CMD : 24-M5

**REGDOC-2.9.2,
*Controlling Releases to
the Environment***

Public Meeting

Submitted by:
CNSC Staff

Figure 1: Conceptual relationship between an upper value of normal operation for a nuclear or hazardous substance, an action level, and a licensed release limit.

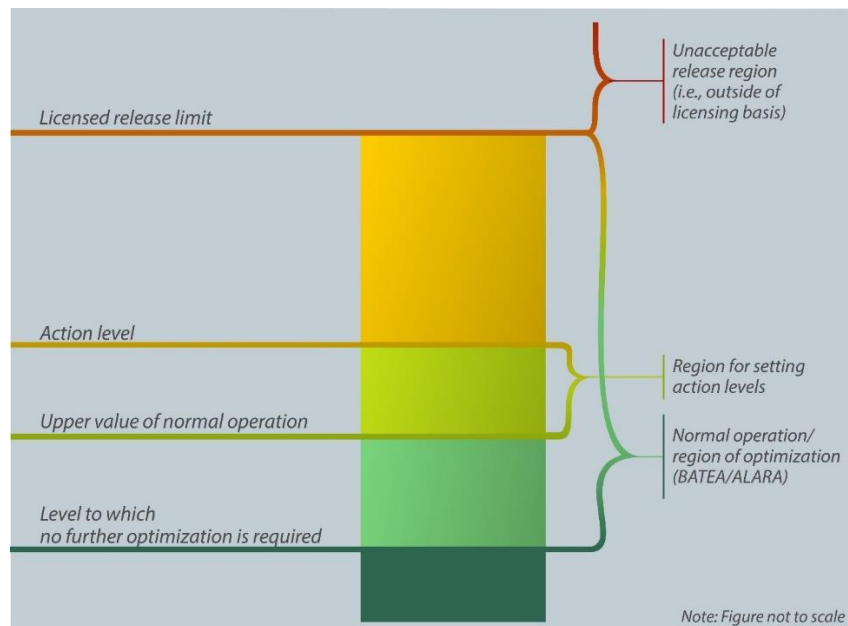
7.	CNA, OPG, Hydro-Quebec, Bruce Power, CNL, NB Power and Cameco.	Submit comments on section 2.1 and 2.1.1	<p>Industry Issue: Clarification</p> <p>The 1st sentence beneath Figure 1 could be interpreted to require optimization beyond 10 µSv/year. Previous sections refer to 10 µSv/yr as the “de-minimus” dose, representing levels in which no further regulatory control is necessary. As written, this introduces the potential for misapplication of the optimization principle – or misinterpretations of the requirements by licensees or other stakeholders.</p> <p>Suggested Change:</p> <p>Revise to read, “...doses approximating 10 µSv/year are recommended as the level below which further optimization and application of BATEA is no longer necessary”</p>	<p>Text Moved to Appendix B</p> <p>Text will be updated to read,</p> <p>“When applying the concept of optimization to establish licensed release limits, modelled doses approximating 10 µSv/year are recommended as the lower boundary for requiring level below which further optimization and application of BATEA is no longer necessary.”</p>

Figure 2: Release performance data for a quantity or concentration of a sample nuclear or hazardous substance over time

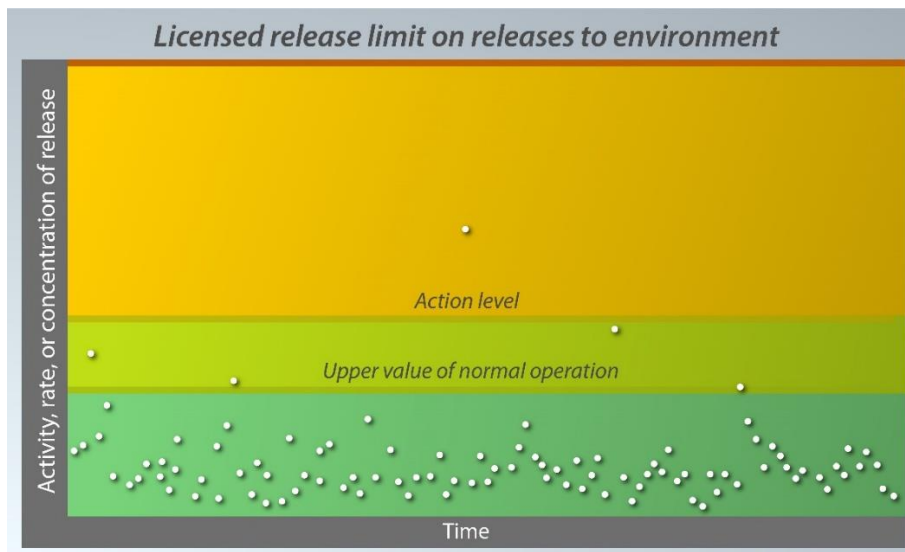
12.	CNA, OPG, Hydro-Quebec, Bruce Power, CNL, NB Power and Cameco.	Submit comments on section 2.2	<p>Industry Issue: Clarification As per Theme #2, Figure 2 is very similar to Figure 1 in CSA N288.8-17 and should be referenced for consistency. There are two different regions in Figure 2 that describe normal operations – “upper value of normal operation” and “Normal Operation/region of optimization (BATEA/ALARA),” which may create confusion. Figure 2 shows that the “maximum predicted design release” should be the same as the licensed release limit.” This is not practicable as the maximum of normal operations likely falls between the upper value of normal operations (e.g., 95th percentile) and the action level based on N288.8-17. This would result in a licensed limit below the action level.</p> <p>Suggested Change: Revise Figure 2 to align with Figure 1 in CSA N288.8-17 and reference this</p>	<p>These figures are not entirely the same.</p> <p>Appendix B.2 has now been created to describe the relationship between environmental release targets, maximum predicted design release, and licensed release limits.</p> <p>For clarity, the term “maximum predicted design release” has been removed from Figure 2.</p>

19.	CNA, OPG, Hydro-Quebec, Bruce Power, CNL, NB Power and Cameco.	Submit comments on section 2.2.3	<p>Industry Issue: Clarification Section 2.2.3 (3rd bullet at the top of page 13) and Section 6 (page 29, 2nd paragraph) state that exceeding an action level “may indicate a deviation from normal operation.” This is inconsistent with Figure 2 where the range of normal operation covers any action level exceedance below the licensed release limit. Although an action level exceedance could be a deviation from normal operation, this would have to also exceed the licensed release limit and, therefore, should more accurately be called a licensed release limit exceedance.</p> <p>Suggested Change: For clarity, delete the 3rd bullet in section 2.2.3 beneath “Exceeding an action level”: Amend the 2nd sentence of the 2nd paragraph in section 6 to read, “Exceeding an action level signals a potential reduction in the effectiveness of the program and/or control measure(s)”</p>	<p>No Change.</p> <p>An action level exceedance, may indicate a deviation in normal operation, and serves as a yellow light (warning) to conduct an investigation to determine whether a loss of control has or may potentially occur, before it does.</p> <p>This is consistent with Figure 2 and the color-coding in Figure 2.</p>
